ADDENDUM NO. TWO
WARREN WOODS PUBLIC SCHOOLS
TOWER HS-TITAN EXPRESS SERVERY
HAWTHORN FOOD PROGRAM FREEZER REPL.
Page 1 of 1 (write up only)

March 24, 2025

ADDENDUM NO. 02 to the plans and specifications for the WARREN WOODS SCHOOL DISTRICT, TOWER HS – TITAN EXPRESS SERVERY-HAWTHORN FOOD PROGRAM FREEZER REPLACEMENT, Warren, MI, Architect's Project No. 242030, dated March 11, 2025

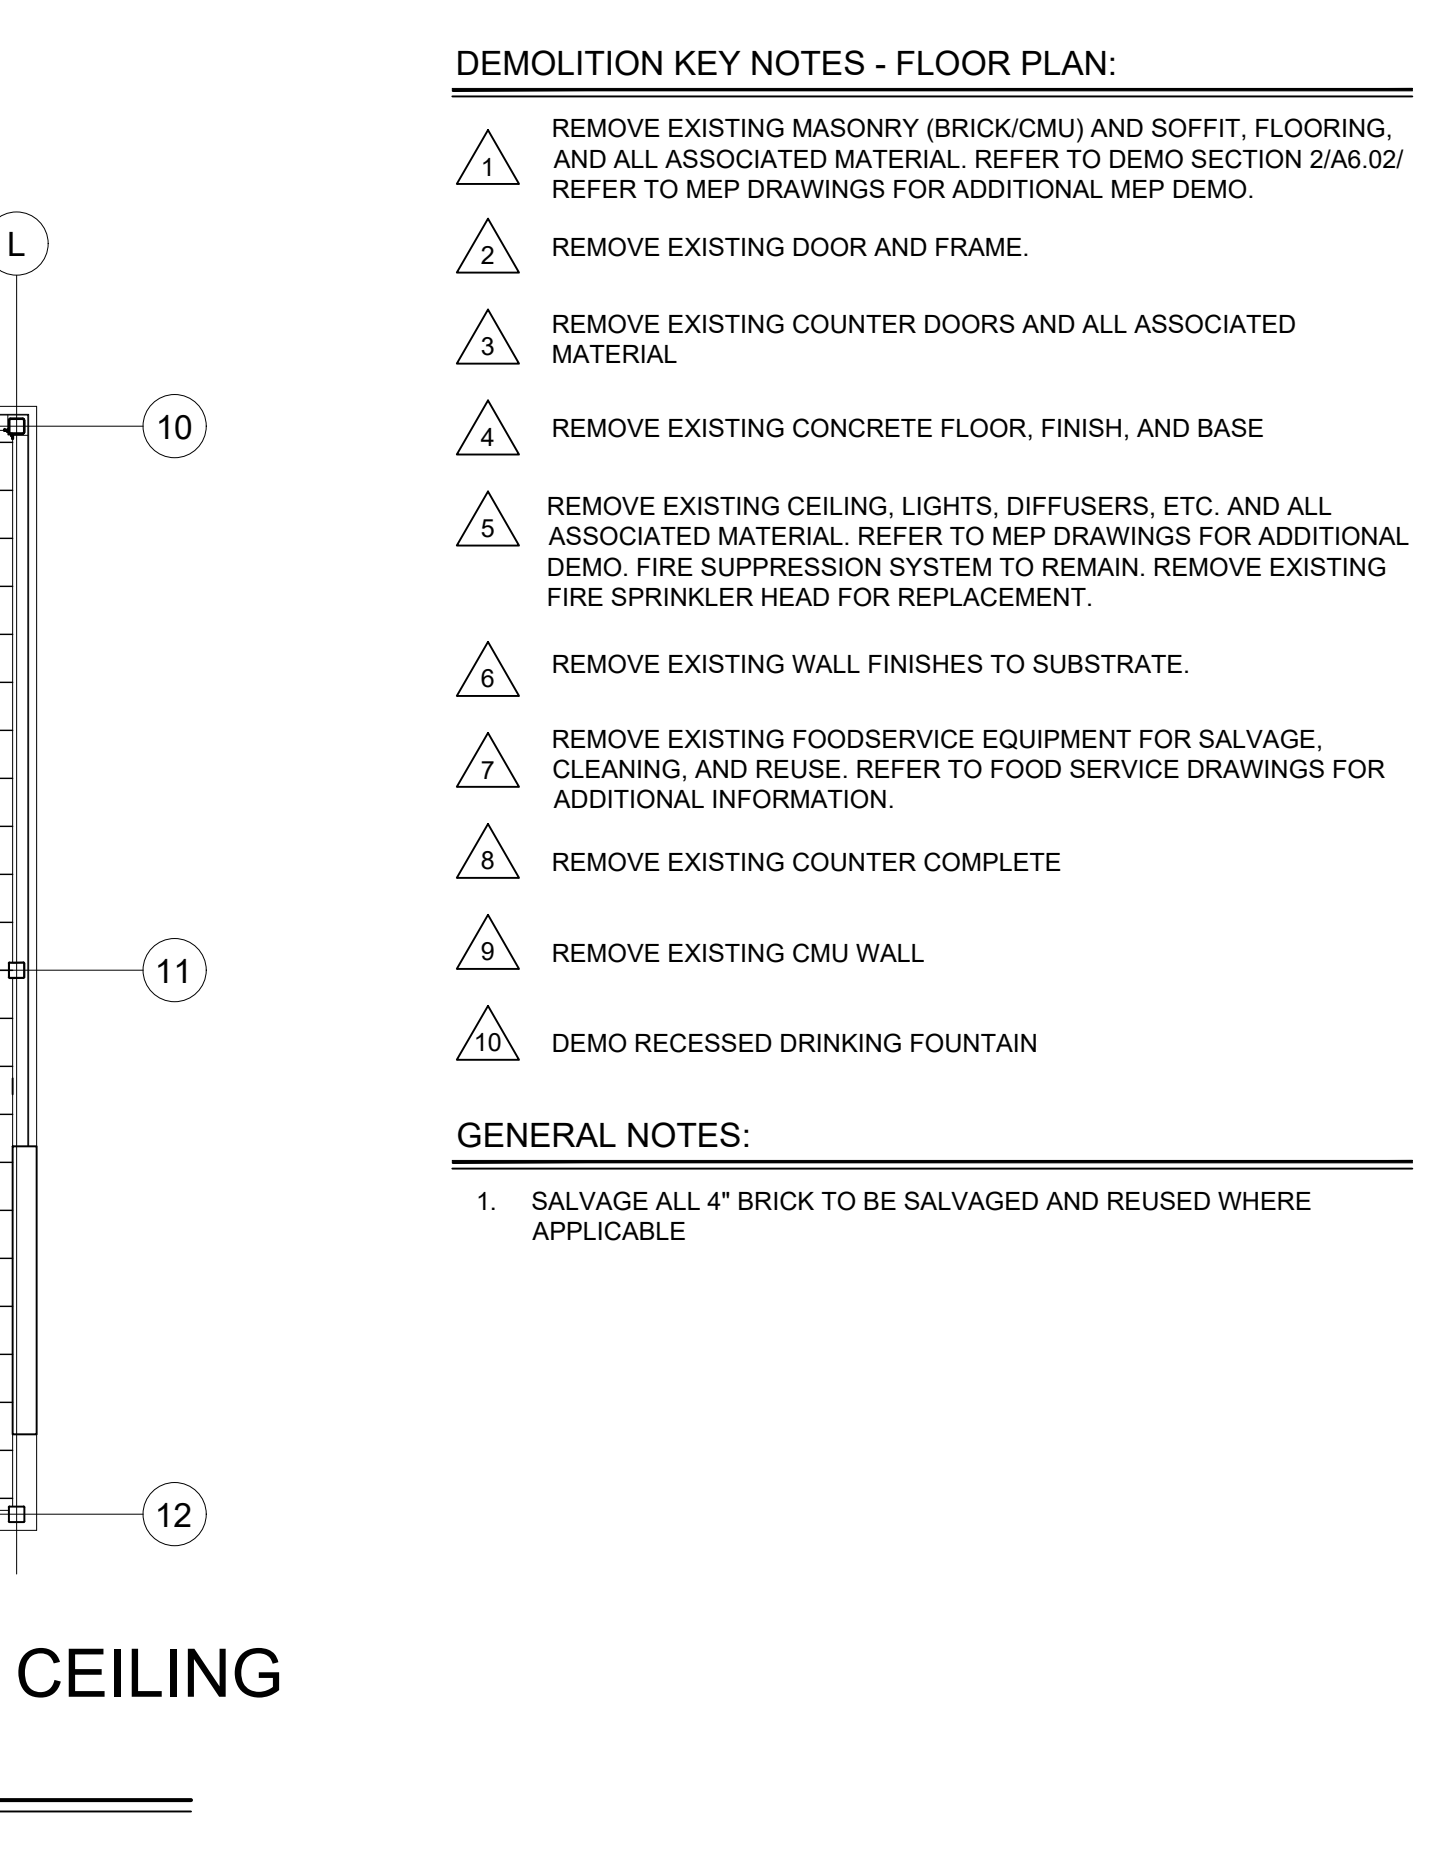
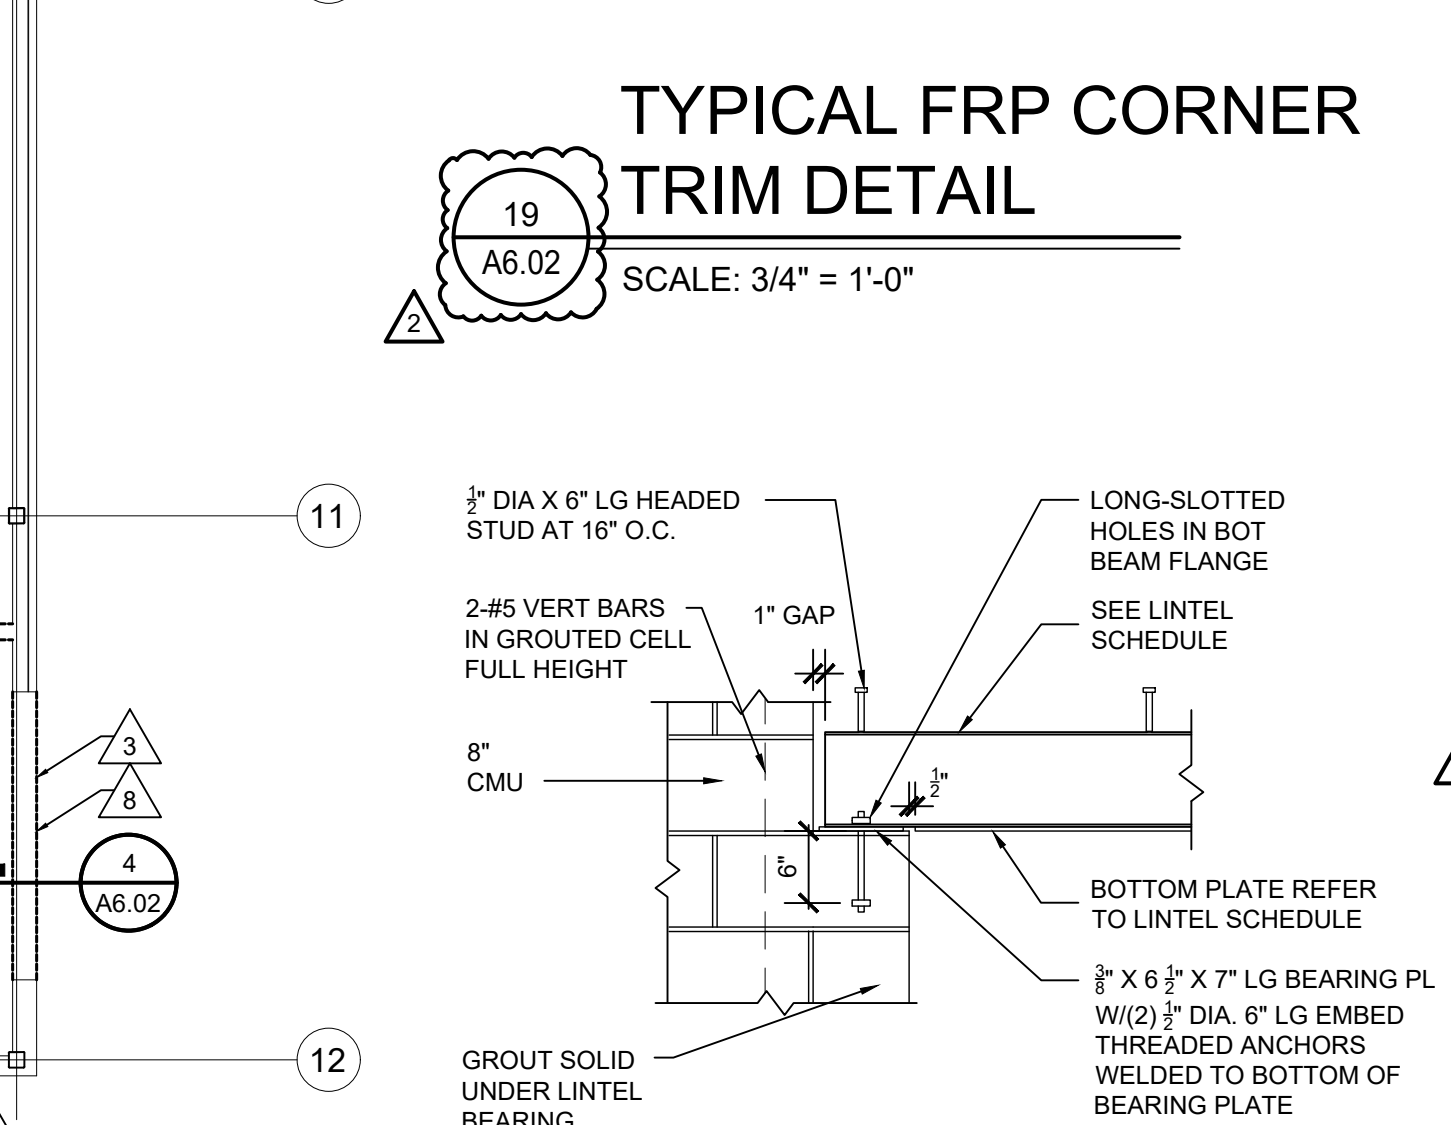
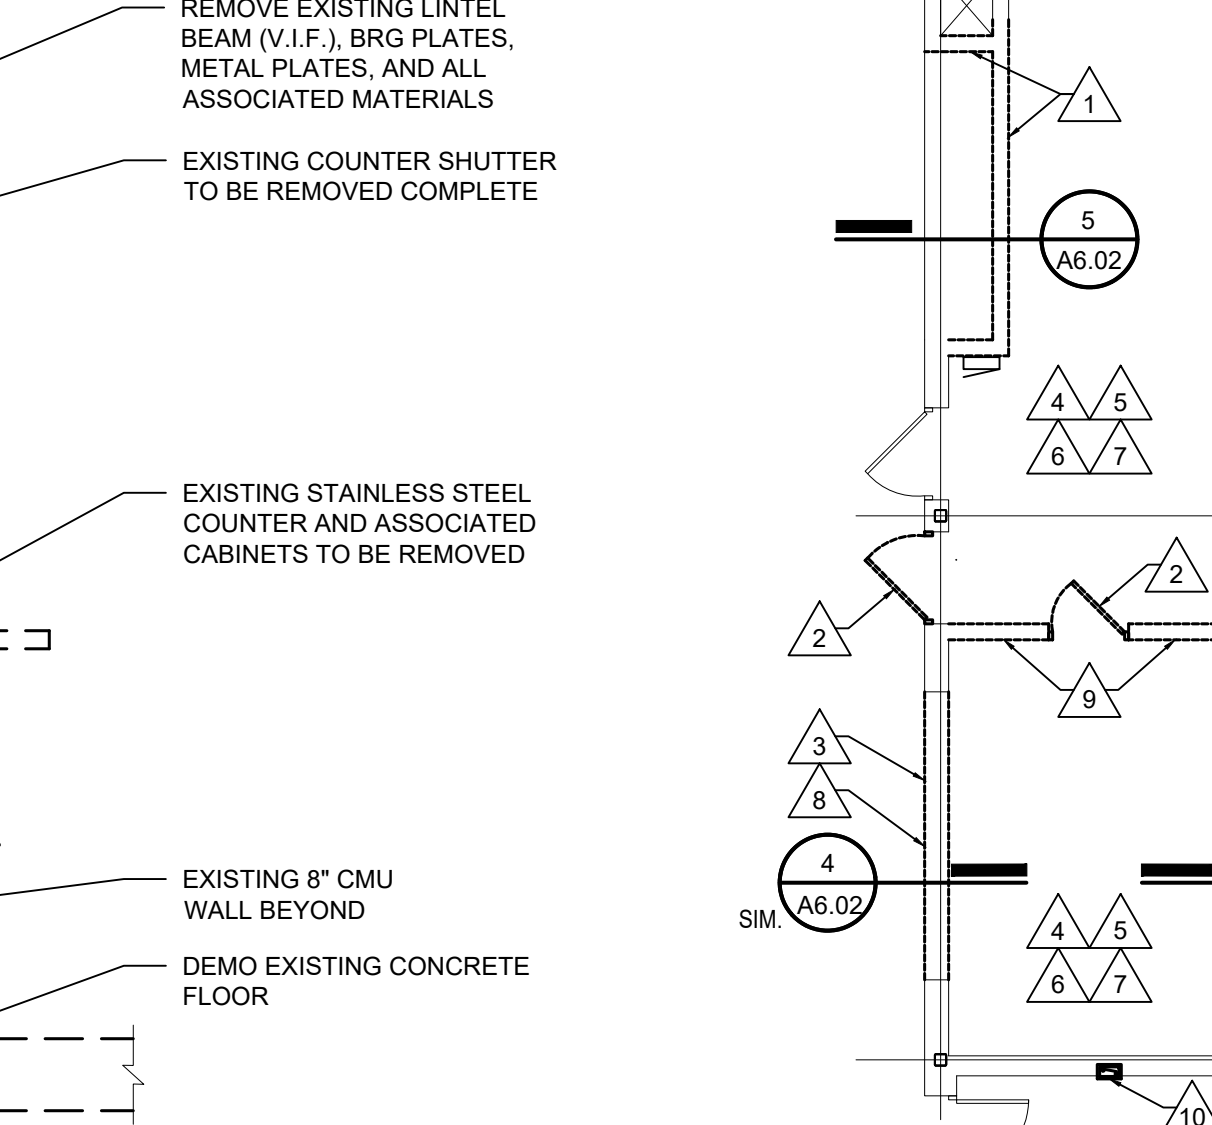
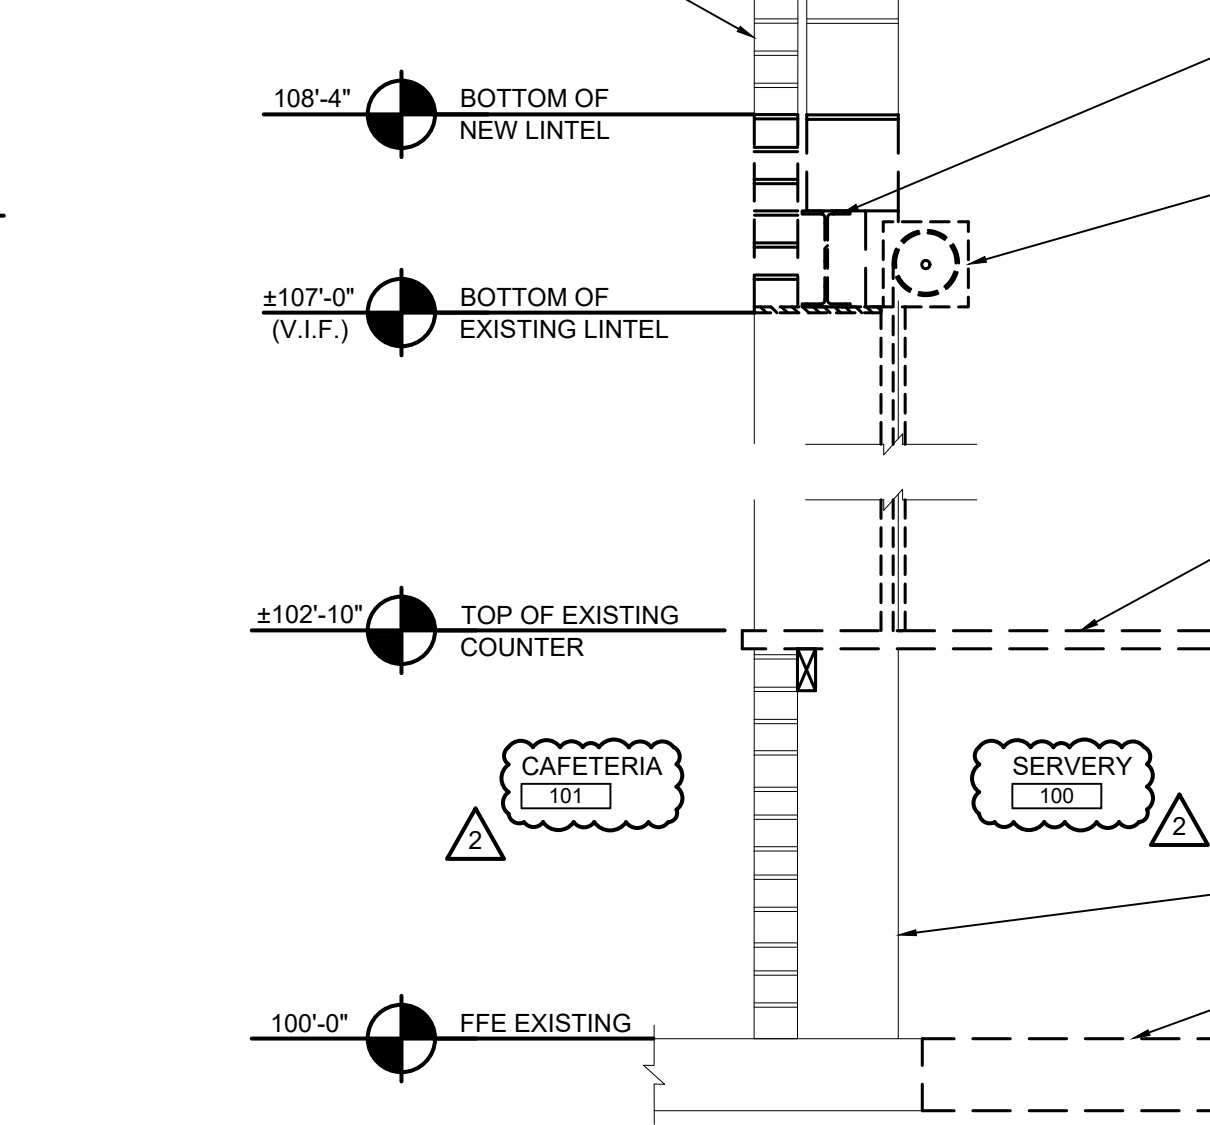
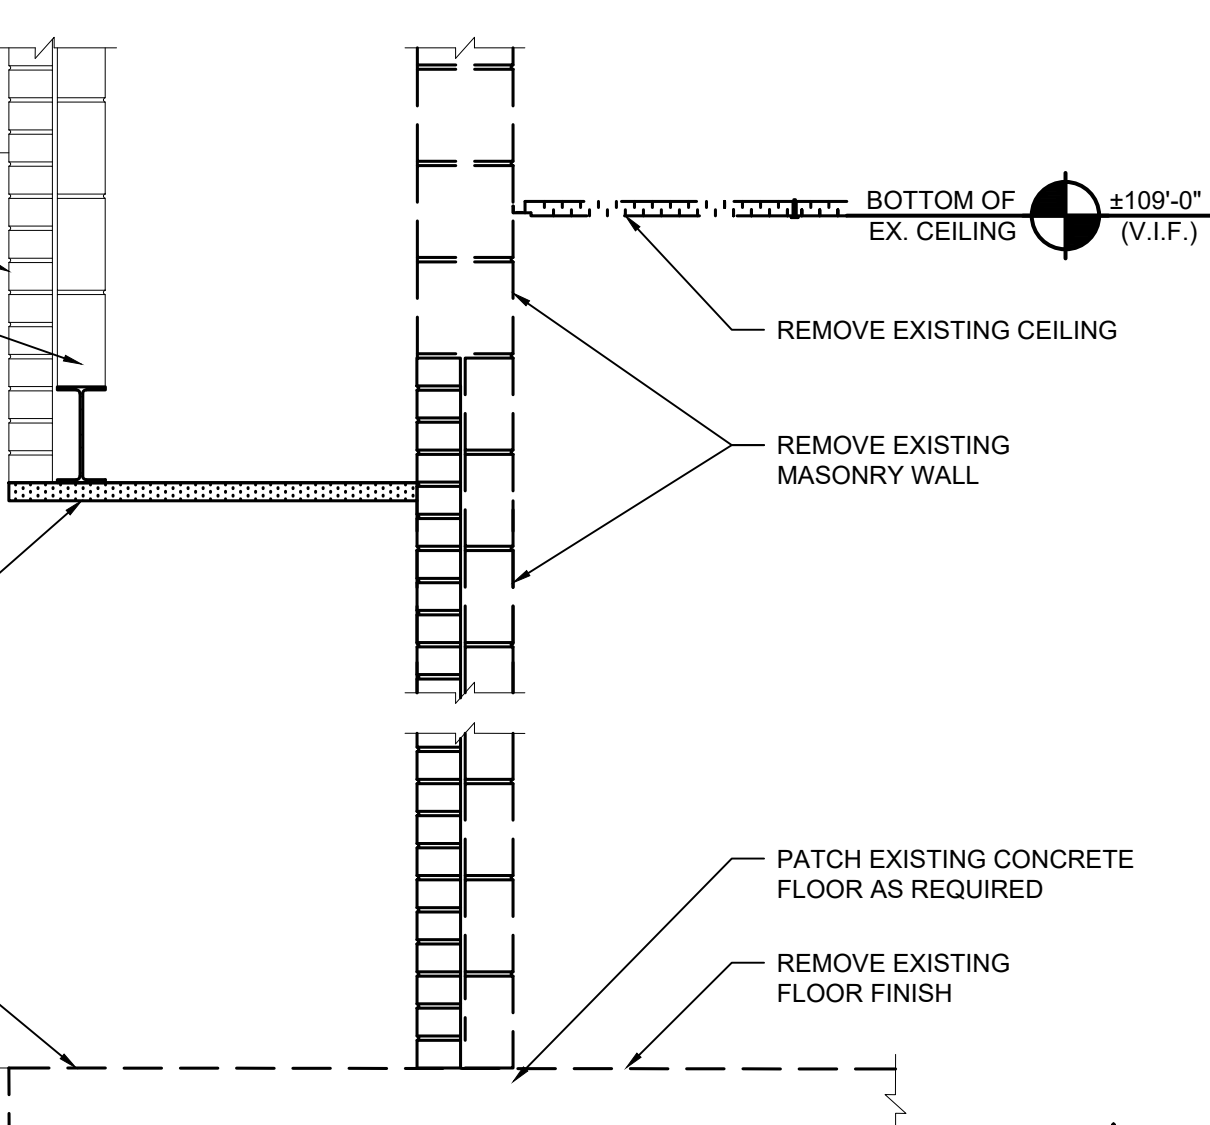
- ITEM NO. A1:** Refer to revised Sheet A6.02 (issued):
1. Added room names on enlarged Plan 2.
 2. Revised Detail 4 indicating to remove and salvage existing brick.
 - a. Clarified room names.
 3. Revised Detail 8 to show new FRP panel and associated backup, revise Spec Section 09772 to match trim and Spec Section 09280, change backup from 1-1/2" rigid furring to 2-1/2" metal studs @ 16" o.c. as shown on revised Detail.
 4. Added Detail 19 showing corner trim at new FRP panel.
